Work Order ID 88746

Item Name: Crosstube Fwd

Reference: REWORK DSI 9544

DART SERVICE INSTRUCTION

FIGURE 1 - GROUNDING STRAP INSTALLATION
(VIEW LOOKING FWD)

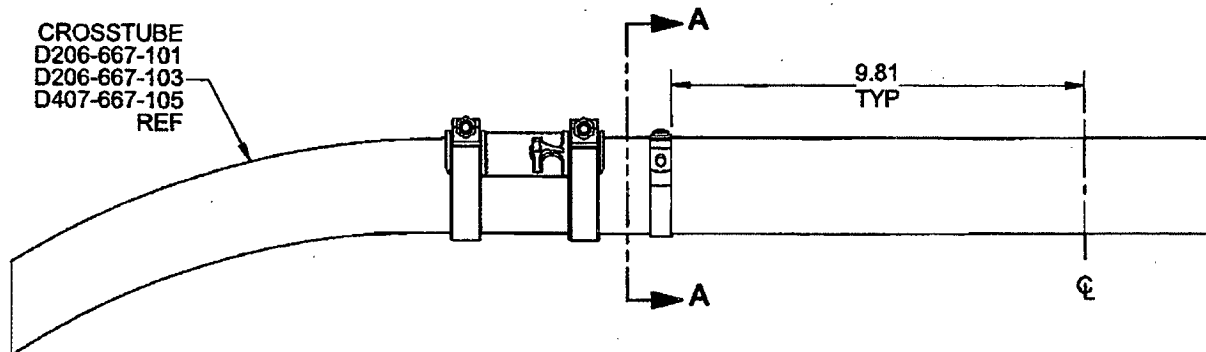
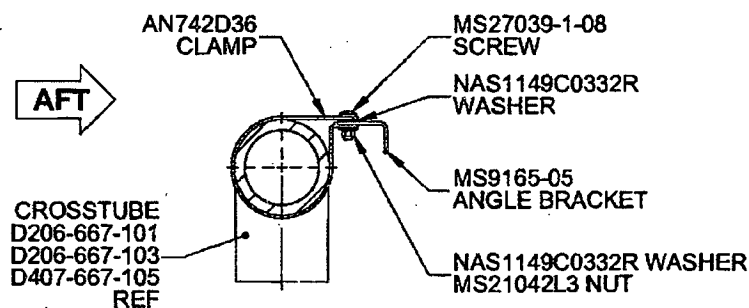
- 1) If installed, follow Section 32.1 of ICA-D206-667 for removal of the forward crosstube from the helicopter.
- 2) Locate AN742D36 Clamp as shown in Figure 1 of this service instruction and mark location of clamp on the crosstube.

- 3) Remove crosstube finish (paint and primer) in area where AN742D36 Clamp will be installed and touch up affected area with chemical film material (Alodine 1200 or 1201) per MIL-C-5541.

- 4) Install AN742D36 Clamp complete with MS9165-05 per Section A-A of Figure 1 of this service instruction.
- 5) Touch up paint as required per Item 5.3.3 of ICA-D206-667.

- 6) Seal edges where AN742D36 Clamp meets with crosstube using Sikaflex-241/291 or MIL-S-8802 Class B2 or Proseal 890 sealant.
- 7) Install/re-install forward crosstube in accordance with Section 32.2 of ICA-D206-667.

- 8) Fasten OEM grounding strap to MS9165-05 Angle Bracket on forward crosstube per Bell instructions.
- 9) Undertake a resistance check between a ground point on the skidtube and aircraft ground in accordance with Class R-II requirement per BHT-ELEC-SPM. Maximum resistance is 10 milliohms (mΩ).
